FORM-BASED ZONING REPORT

▶ **FILE #:** 4-A-26-OB **AGENDA ITEM #:** 13
 POSTPONEMENT(S): 4/9/2026 **AGENDA DATE:** 5/14/2026
 ▶ **APPLICANT:** RYAN ROBERTSON
 OWNER(S): Doyle E Arp Kerbela Temple Holding Corp.

Zoning Administrator Report for Level III: Alternative Compliance Review

315 Kerbela Avenue

Site Plan - Architectural (New Design)

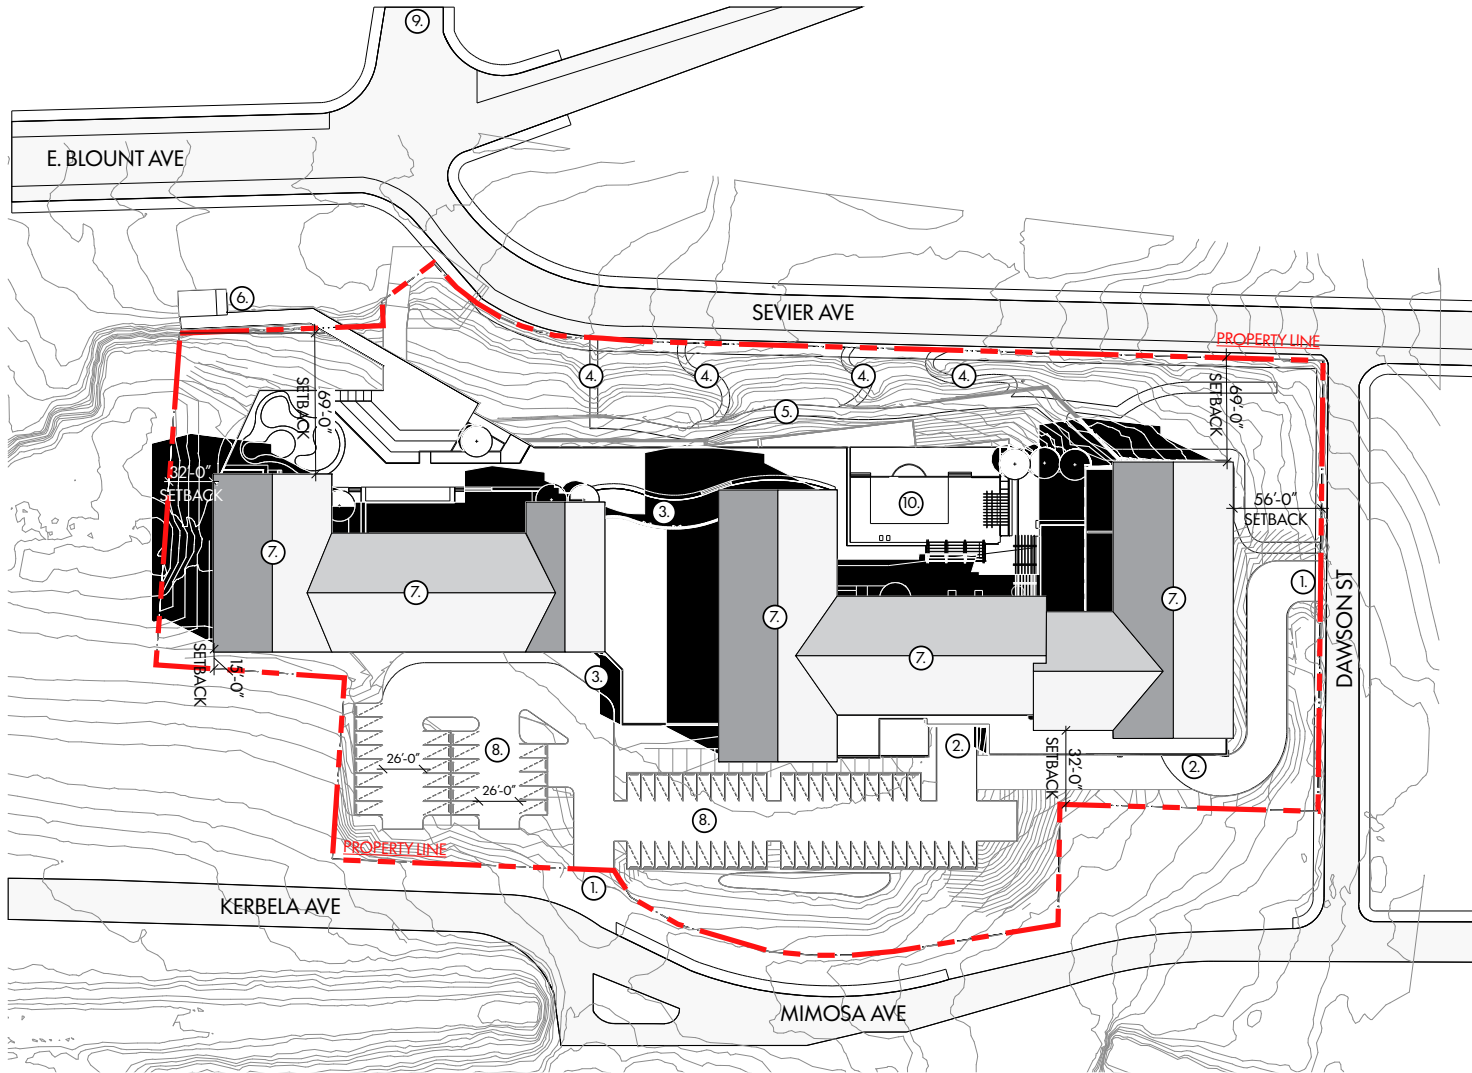
- Article 7.1.3.F.4 & 7.1.3.G.4–Principal Building Siting – Front Setback – 0’. The site plan provided shows a front setback of 69’-0” from Sevier Avenue. This does not meet the front setback standard and will need approval as a Level III: Alternative Compliance Review.

- Article 7.1.3.F.4 –Principal Building Siting – Frontage at Setback (min) – 75% to River Rd. and Sevier Ave. The site plan provided shows the building sited beyond the front setback and therefore the development does not meet the frontage at setback minimum of 75%. This will need approval as a Level III: Alternative Compliance Review.

- Article 7.1.3.F.4 & 7.1.3.G.4 –Principal Building Siting – Side Setback (max) – 25’. The site plan provided shows the building sited at 56’-0” from the Dawson St. interior side lot line and the building sited 32’-0” from the eastern interior lot line both of which are over the maximum side setback of 25’. This will need approval as a Level III: Alternative Compliance Review.

North Elevation

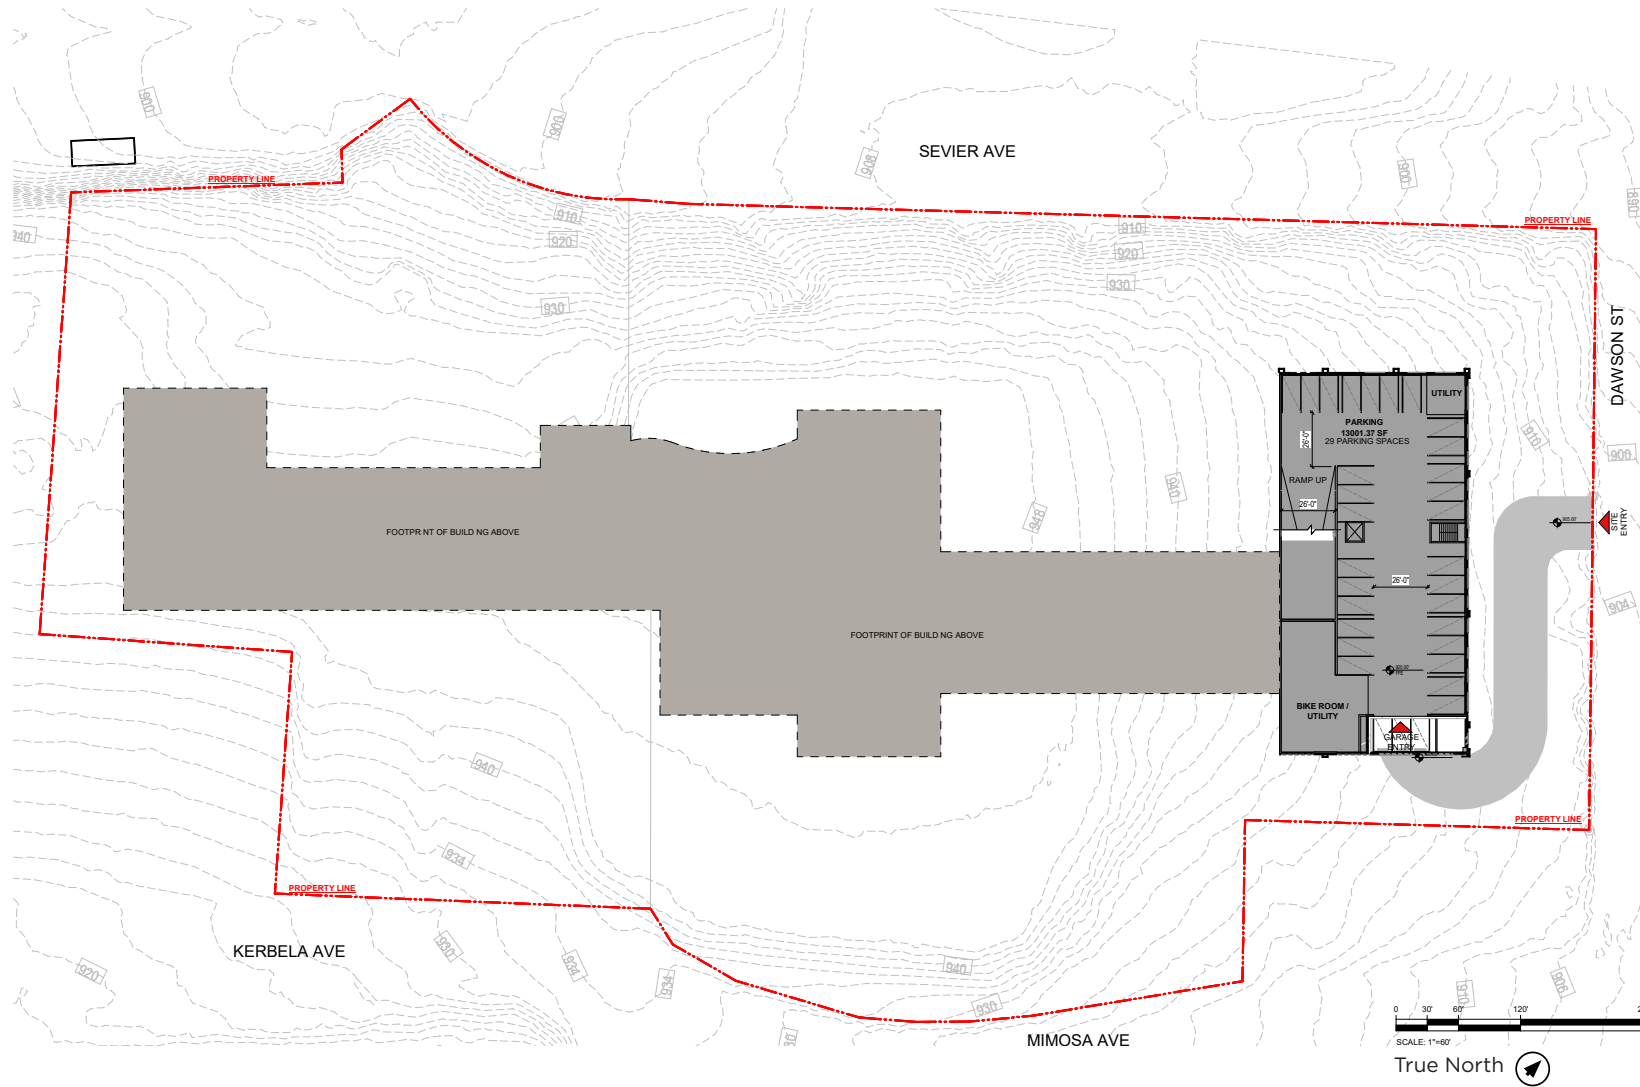
- Article 7.1.3.F.6 & 7.1.3.G.6– Building Entries – Ground Level - Min 70% transparent glass at the ground level on the principal frontage. The provided elevations show a ground floor glazing calculation of 71%; however, there is a note that suggests that the

ground floor area of the garage was excluded from the calculations. The ground floor area of the garage shall be included in the calculations and the complete ground floor transparency calculation is unable to be determined on your elevation plan. Please provide a transparency calculation that includes the garage ground floor area. If the calculation is less than 60%, it will need approval as a Level III: Alternative Compliance Review.
